**DEPARTMENT OF COMMERCE****National Oceanic and Atmospheric Administration****RIN 0648–XD394****Takes of Marine Mammals Incidental to Specified Activities; Marine Geophysical Survey in the Northwest Atlantic Ocean Offshore North Carolina, September to October, 2014**

**ACTION:** Notice; issuance of an incidental harassment authorization.

**SUMMARY:** In accordance with the Marine Mammal Protection Act (MMPA) implementing regulations, we hereby give notice that we have issued an Incidental Harassment Authorization (Authorization) to Lamont-Doherty Earth Observatory (Lamont-Doherty) a component of Columbia University, in collaboration with the National Science Foundation (Foundation), to take marine mammals, by harassment, incidental to conducting a marine geophysical (seismic) survey in the northwest Atlantic Ocean off the North Carolina coast from September 15 through October 31, 2014.

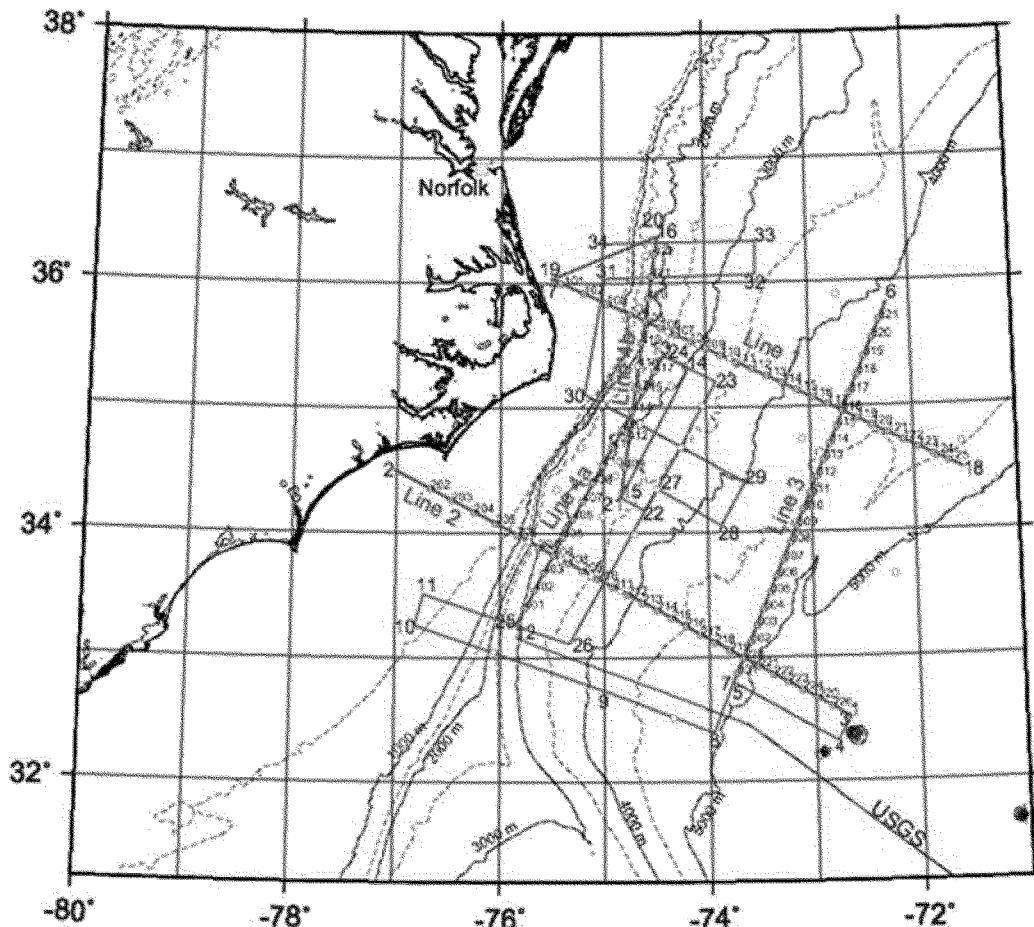
**Comment 4:** The Commission described our proposed requirement for the *Langseth* to conduct the survey (especially when near land) from the coast (inshore) and proceed towards the sea (offshore) to the maximum extent possible. The Commission agrees with this requirement, but recommends that we remove the qualifying phrase ". . . to the maximum extent practicable . . ." within the Authorization.

**Comment 15:** NRDC *et al.* states that Lamont-Doherty provides no justification for the particular trackline configuration (see Addendum) and why that design elected to remove the 25 percent contingency that it typically adds to its tracklines, as opposed to other potential designs represents the least practical adverse impact on marine mammals. They further state that we should limit Lamont-Doherty to both the specified tracklines and the specified number of line-kilometers, and require cessation of the activity when they reach the latter.

**Response:** Lamont-Doherty has planned the survey to comply with the requirement to conduct acquisition activities from the coast in a seaward direction to the maximum extent practicable. However, this requirement may not be practicable in all situations. In a few cases, Lamont-Doherty must acquire data (see Lines 1 and Lines 2 in Figure 1 in this notice) transiting

towards the coast to meet their research goals such as when switching from an OBS line to a MCS line. We have evaluated the commenter's recommendation and Lamont-Doherty's reasons for why the measure may (or may not) be practicable and have concluded that after taking into consideration the project's purpose, there is no practicable alternative for Lamont-Doherty's proposed acquisition activities. Thus, for this Authorization we will not remove the qualifying phrase to the maximum extent practicable.

**Response:** See our response to Comment 14. For this survey, Lamont-Doherty assumes that the *Langseth* will not need to repeat some tracklines, accommodate the turning of the vessel, address equipment malfunctions, or conduct equipment testing to complete the survey. Lamont-Doherty added a 25 percent contingency allowance in their application and draft EA to their ensonified area calculations for additional seismic operations in the survey area associated with infill of missing data, and/or repeat coverage of any areas where initial data quality was sub-standard; however, they have eliminated the contingency from their final calculations. Whereas Lamont-Doherty added this 25 percent contingency to some past seismic surveys, for this particular survey design, the additional contingency was not necessary and removed from the final calculations for the proposed activities. Thus, total tracklines for the proposed survey would not exceed 5,320 km.

We have revised the take estimates to account for the 10 tracklines that would require repeat coverage. The Authorization accounts for the modified number of tracklines (including repeated tracklines) shown in Figure 1 in this notice. We note that unlike previous seismic surveys aboard the *Langseth*, Lamont-Doherty would conduct the 2-D survey as almost one continuous line. Therefore, the ensonified area for the seismic survey does not include a contingency factor (typically increased by 25 percent to accommodate turns and equipment testing, etc.) in line-kilometers. Also, any marine mammal sightings within or near the designated exclusion zones will
